Re: Docket No. CSC 461A - Greenwich Substation and Line Project, Development and Management Plan, Vol. 1, Part 1- Cos Cob Substation Modifications

**CL&P dba Eversource Energy
Docket CSC 461A - Greenwich Substation and Line
Project, Development and Management Plan, Vol. 1,
Part 1- Cos Cob Substation Modifications**

**Data Request CSC-01
Dated: 03/19/2018**

TITLE
 COS COB 11R
 115KV LIGHTING & PHOTOMETRIC PLAN
 PLAN VIEW
 GREENWICH, CT

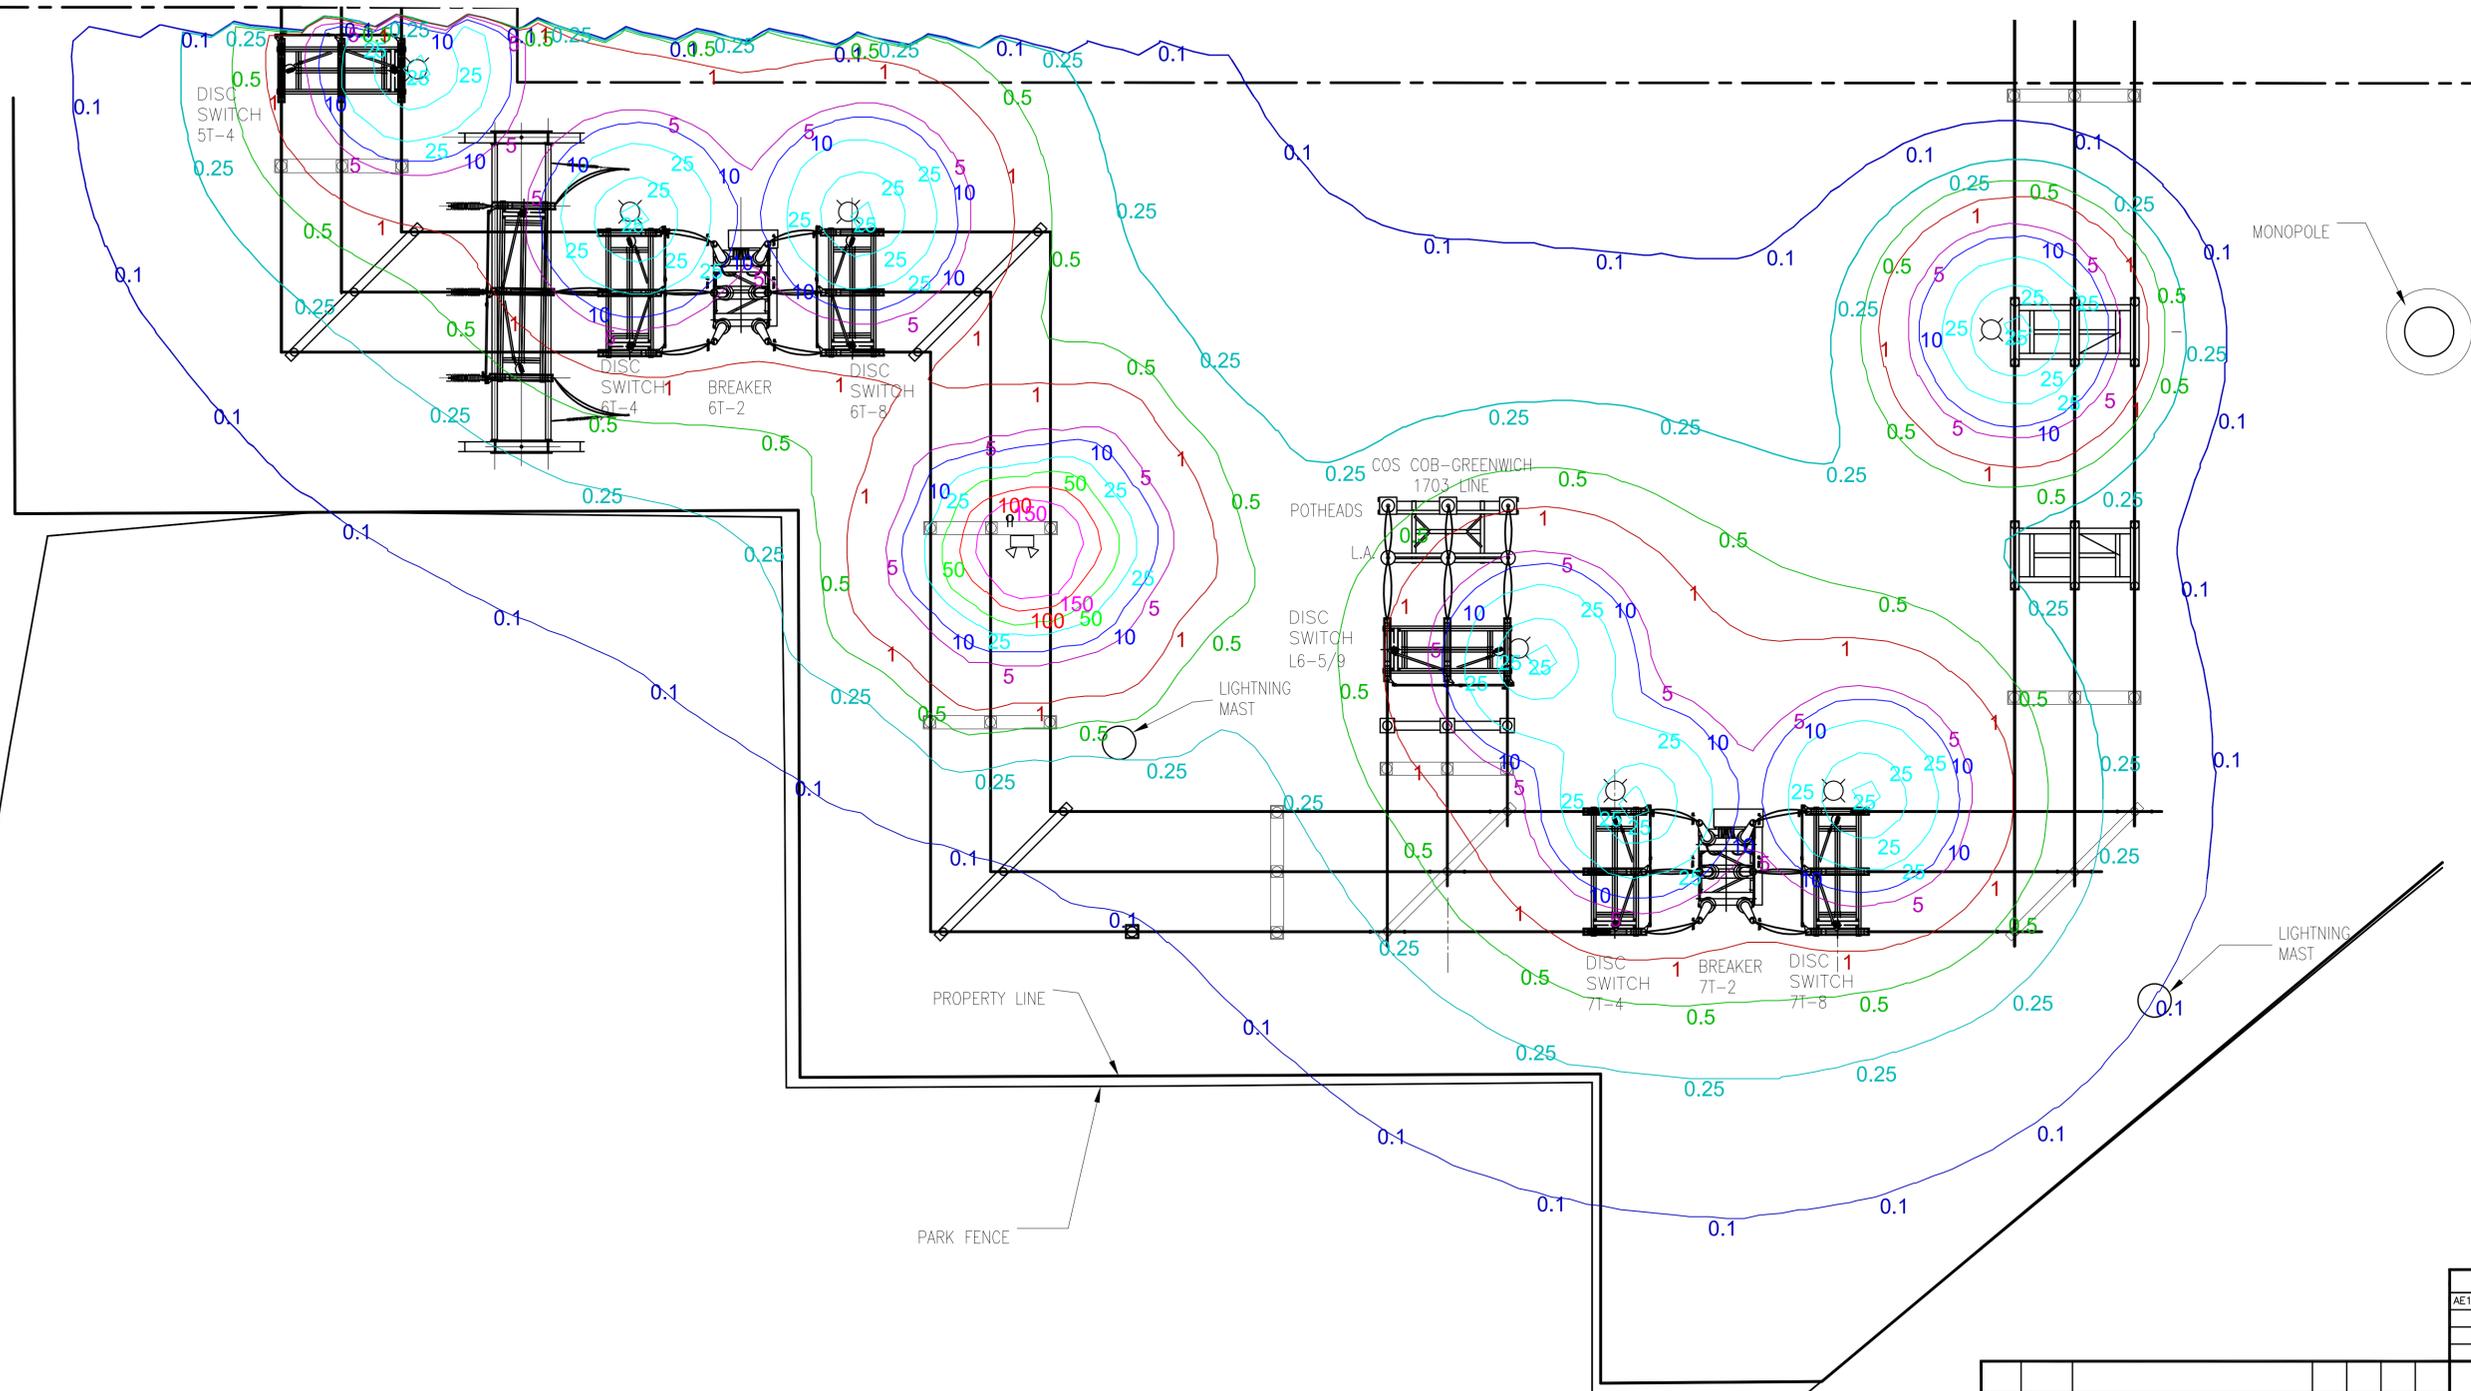
D&M narrative p. 29 states post-construction lighting would be similar to existing lighting. Please provide a lighting plan and indicate methods to prevent light trespass onto adjacent property.

Please see the attached lighting plan, which provides the level of illumination in foot candles anticipated to result from the additional lighting sources planned for installation at Cos Cob Substation as part of the Project work. The highest modeled rating along the property boundary is 0.25 foot candle, with most of the property boundary at 0.1 foot candle. For comparison, parking area lighting is typically 1-2 foot candles. The proposed lights are similar to the existing substation lighting.

The proposed lighting would only be utilized during non-daylight work at the substation, which may include switching, maintenance or night time emergency response. When in use, light from the substation will be mitigated by the use of downward directed lighting.
